GENERAL APPLICATION

Explanation of Request: 15-unit Multi-Family Apartment building

Preliminary Site Plan Review

1 SITE PLAN
1/8" = 1'-0"

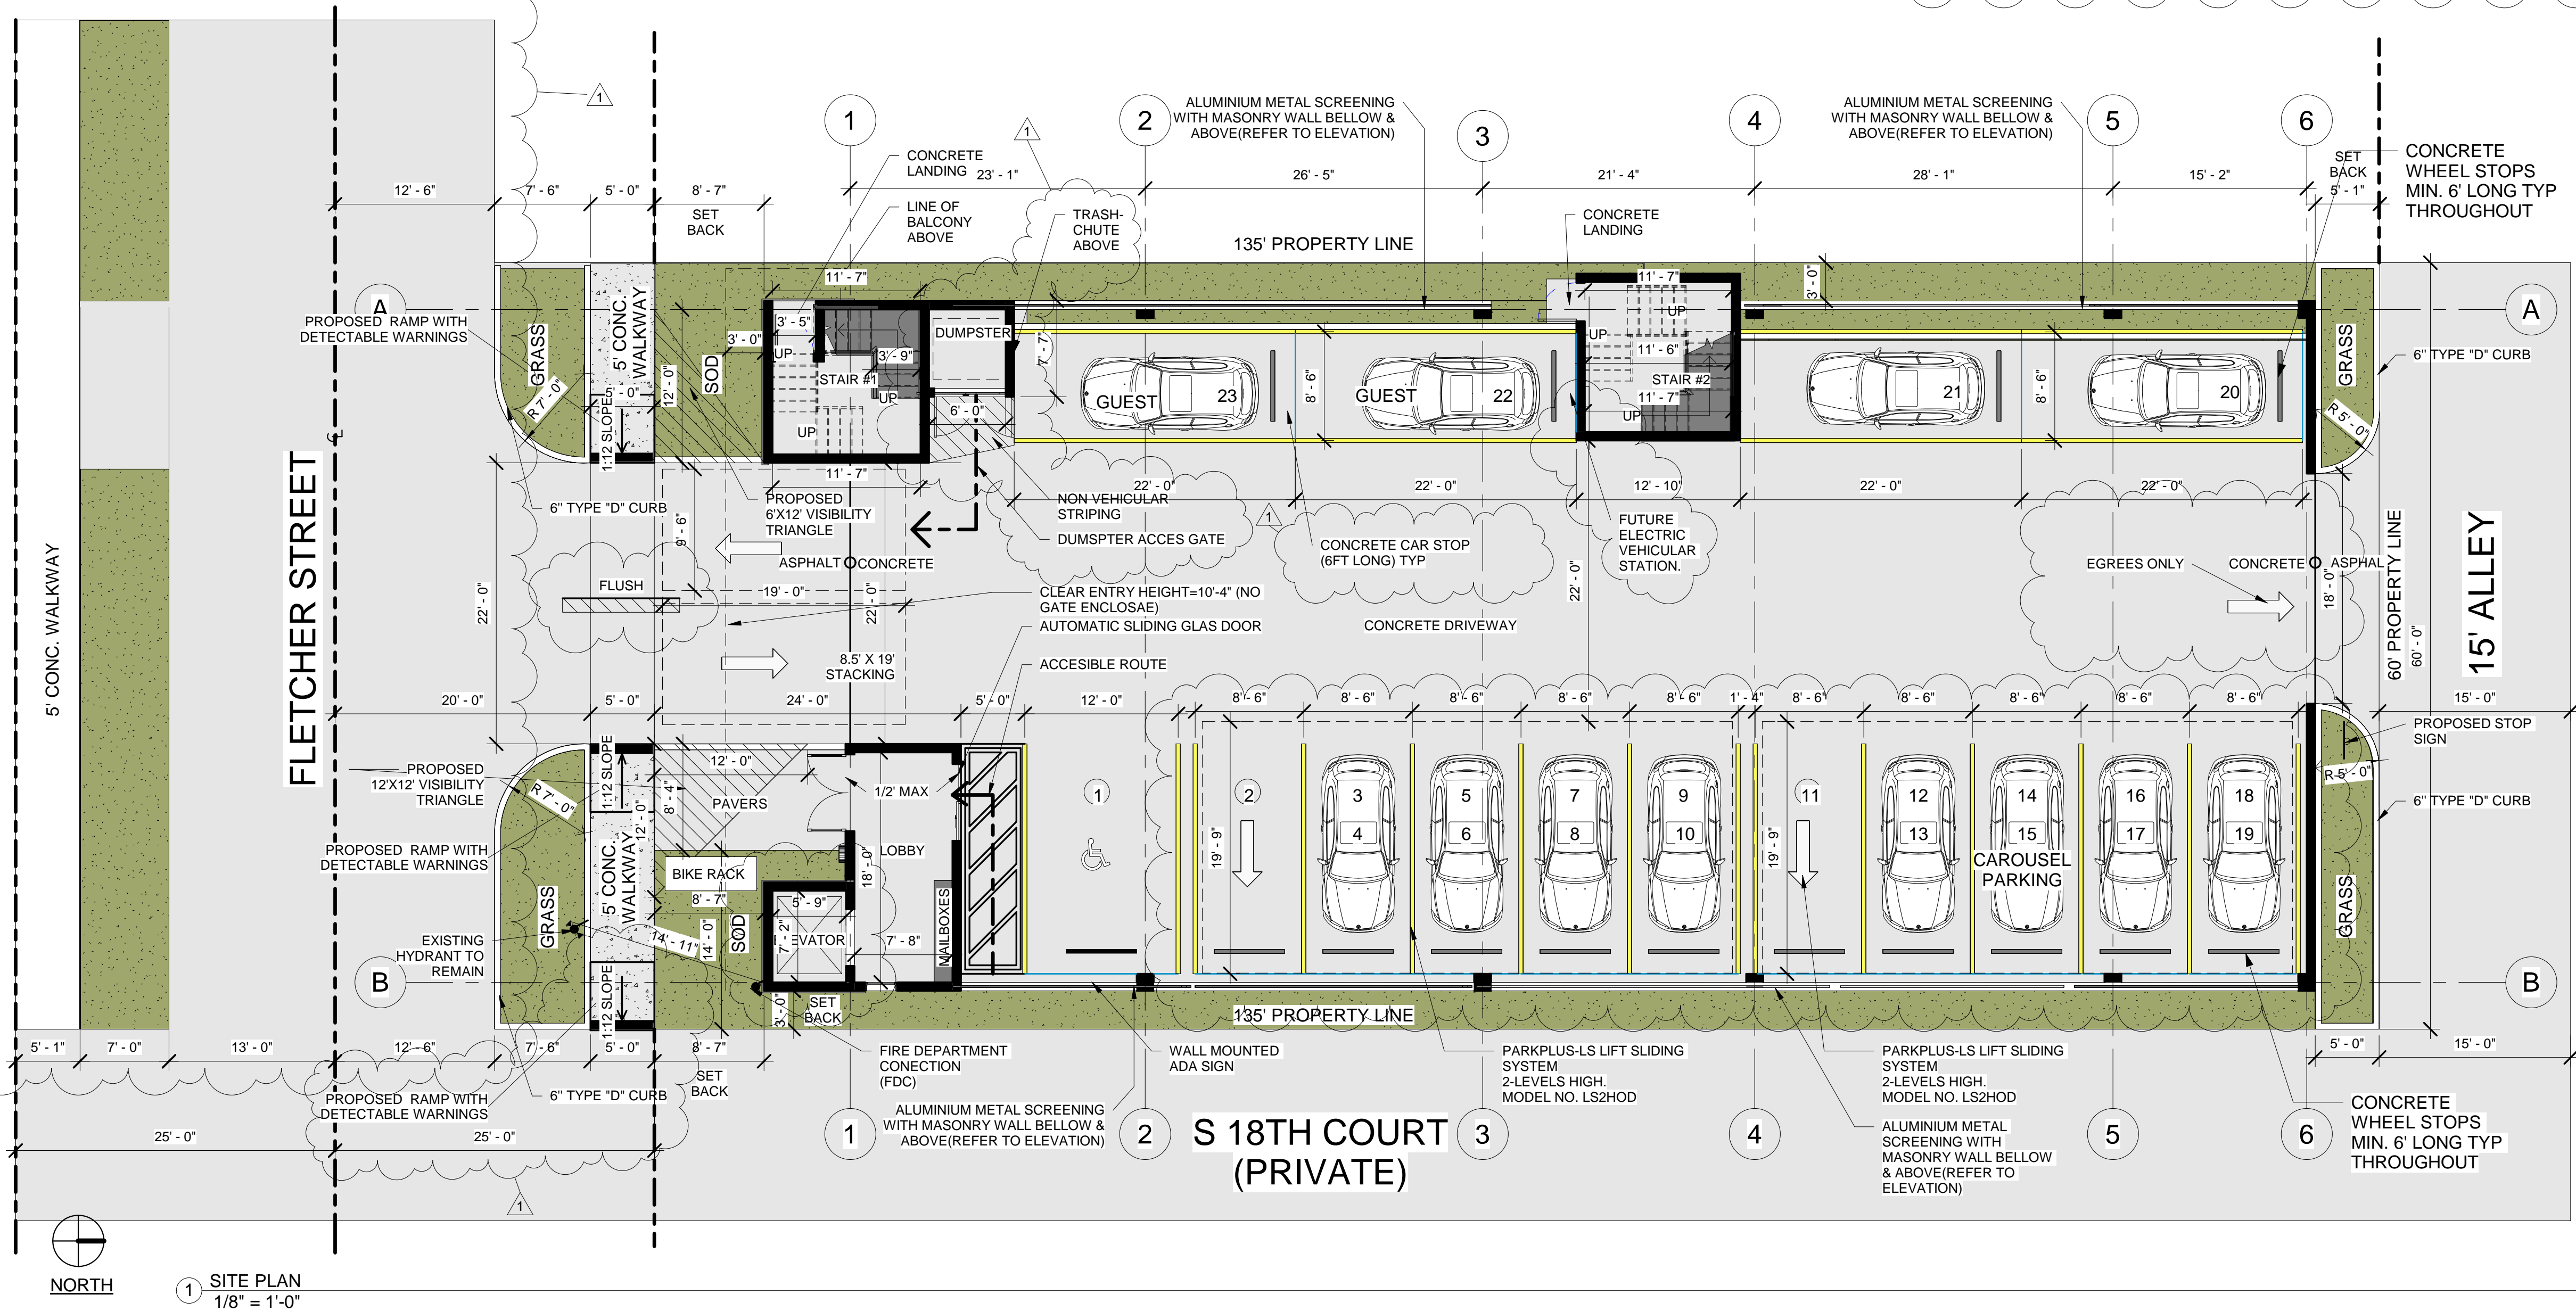
a. Include a note on the site plan indicating that all changes to the design will require planning review and may be subject to Board approval.

g. Indicate concrete car stops (6ft long) for parking spaces on the site plan. SP 1.1

2. Indicate and demonstrate access to the dumpster on site plan.

1. Provide note on Site Plan: “All signs, which are electrically illuminated by neon or other means, shall require a separate electrical permit and inspection. Separate permits are required for each sign.”

2. Indicate on the site plan where the infrastructure necessary for future installation of electric vehicle-charging equipment will be located. (See 151.154, Ordinance O-2016-02) Consider placing it adjacent to a handicapped space so that the future charger will be accessible from both types of spaces. Recommend to locate the charging stations in the visitor parking spaces.

4. Provide an overall site plan with the following information:

14. On site and civil plans, please provide dimensions for the vehicular queueing space. This space should be 19' by 8.5' minimum and should be measured after the property line and before any parking stalls.

17. On site plan, sheet SP 1.1, the parking area calls out for an asphalt driveway. However, on civil plans, sheet C-1.1, the parking area is divided between asphalt and concrete. Please clarify.

Response: Provided, on sheet SP-1.1

Response: Added note on sheet SP-1.1 & A-1.1

Response: Provided, refer to sheet SP-1.1

Response: Provided, refer to Sheet SP-1.1

Response: Provided, refer to Sheet SP-1.1

Response: Provided, refer to sheet SP-1.1

Response: Provided, refer to sheet SP-1.1

Response: Corrected accordingly

6 VUA PLAN
1" = 30'-0"

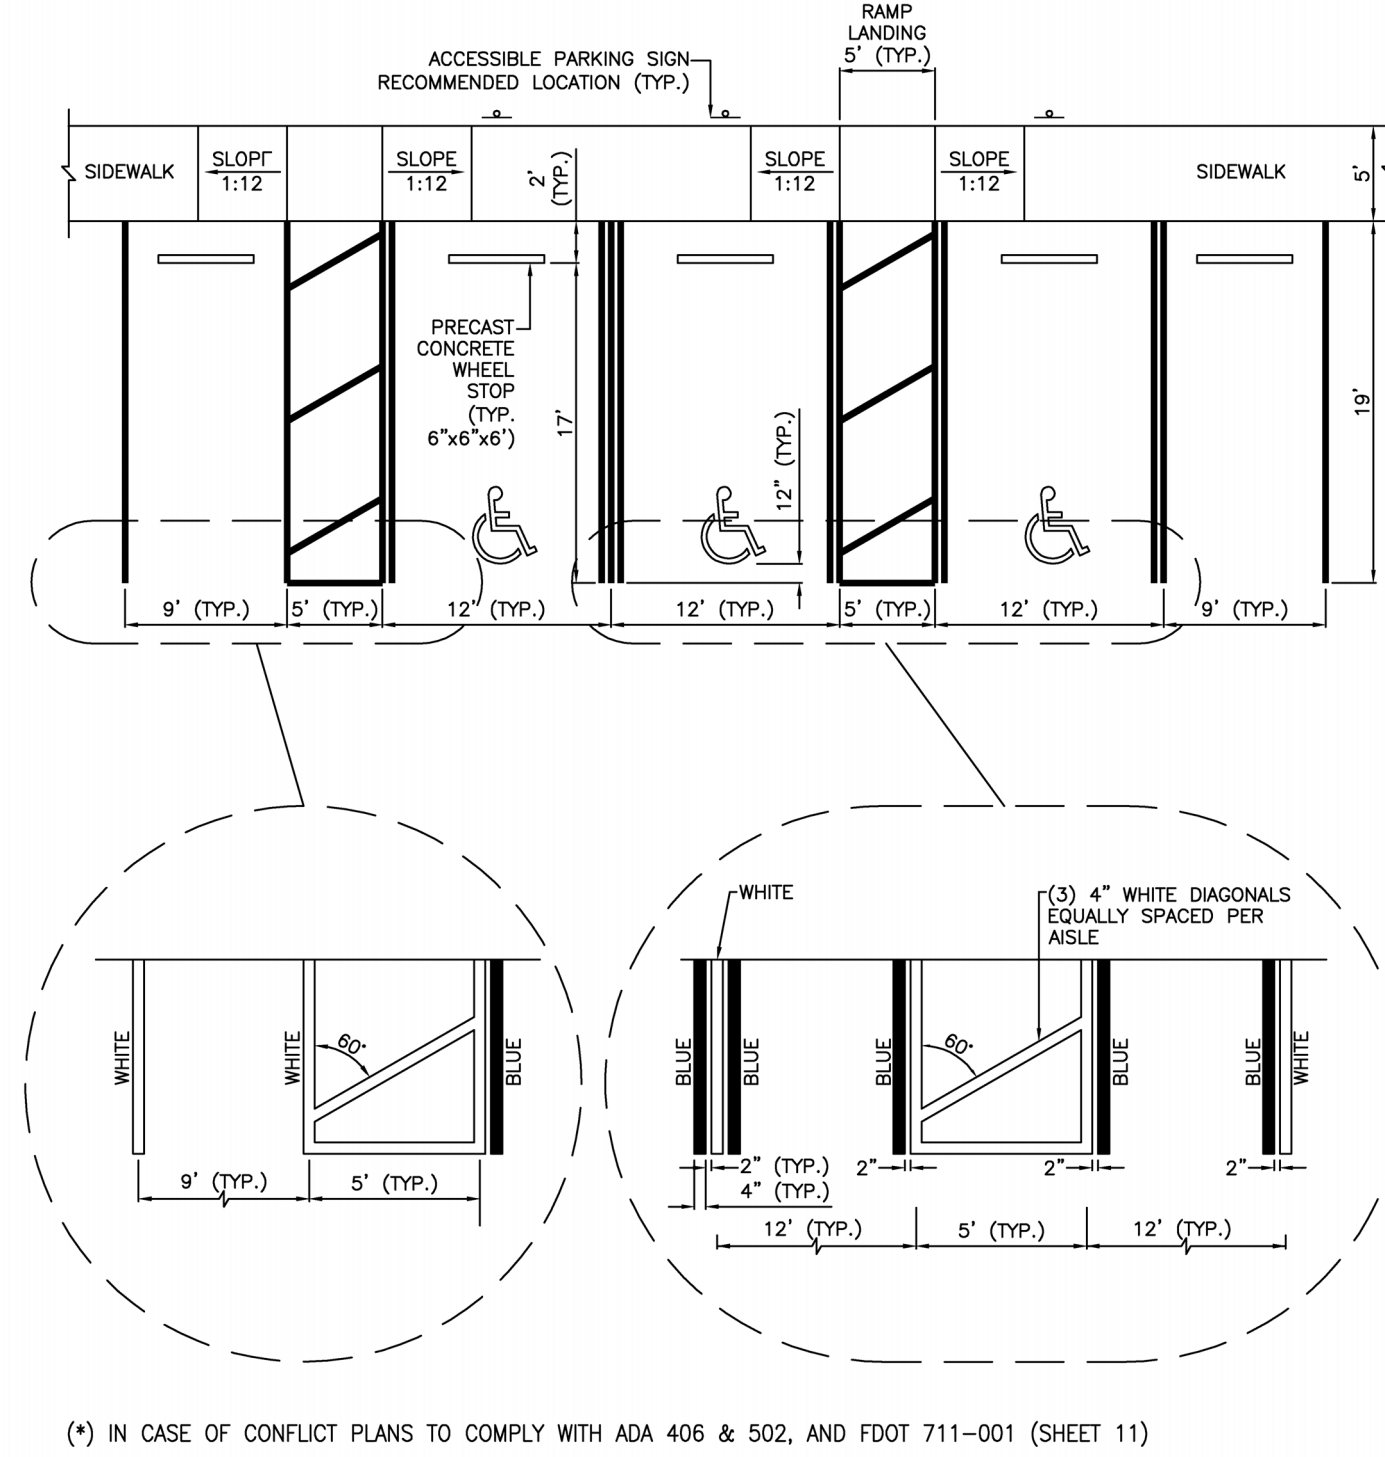
e. Provide VUA calculation. Please see section 4.6(3)(d)(3) of the code.

Response: Provided, refer to Sheet SP-1.2
